## **RESUBDIVISION OF** **SALVATION ARMY SUBDIVISION**

APPLICATION NUMBER 12 DATE February 19, 2009  
 APPLICANT Salvation Army Subdivision, Resubdivision of  
 REQUEST Subdivision

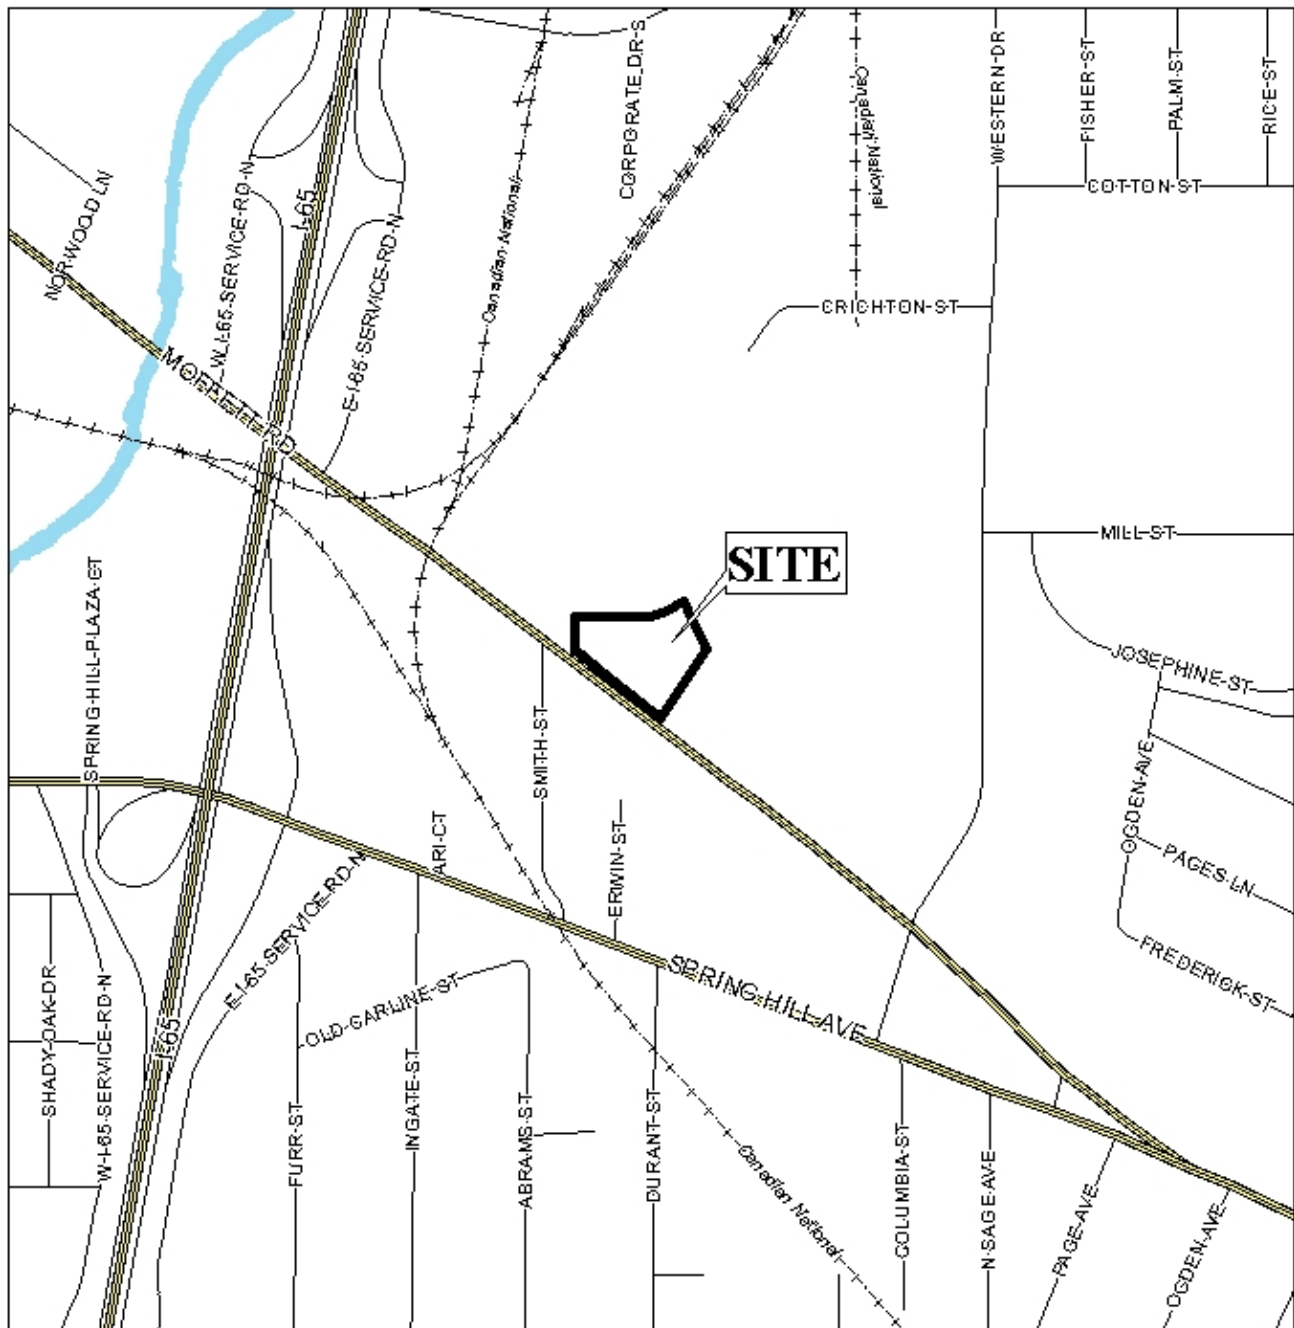
The proposed Lot "A" is depicted with 25 feet of public right-of-way frontage along Moffett Road and 50 feet of public right-of-way frontage along the unimproved, unopened Crichton Street right-of-way. Additionally, the 25-foot frontage along Moffett is separated from the remainder of the proposed lot by a 35-foot wide drainage easement and open ditch. The proposed Lot A is approximately 42 feet wide at the 25-foot setback line. Applying the maximum depth rule in Section V.D.3 of the Subdivision Regulations, the maximum depth allowed for this lot would be approximately 147 feet. As depicted, the lot's depth is approximately 380 feet. Additionally, a drainage easement is depicted that encompasses 25 to 35 feet of the lot in places, leaving, at times, only about 19 feet of buildable width. The narrowness of the lot, combined with inadequate right-of-way frontage, and the presence of a substantial drainage easement on a large section of the site calls into serious question the suitability of the lot as a building site.

The proposed Lot "B" is depicted with over 365 feet of public right-of-way frontage along Moffett Road. Lot "B" is depicted as being mildly impacted by the existing drainage easement

mentioned earlier, with an approximately 10-foot wide strip of the easement running along the northern boundary of the proposed lot. The proposed Lot "B" is of sufficient size and has sufficient frontage to meet the minimum standards of the Subdivision Regulations.

- 1) The proposed Lot "A" exceeds the maximum depth allowed per Section V.D.3 of the Subdivision Regulations; and
- 2) The proposed Lot "A" does not have an adequate buildable site due to the existing drainage easement.
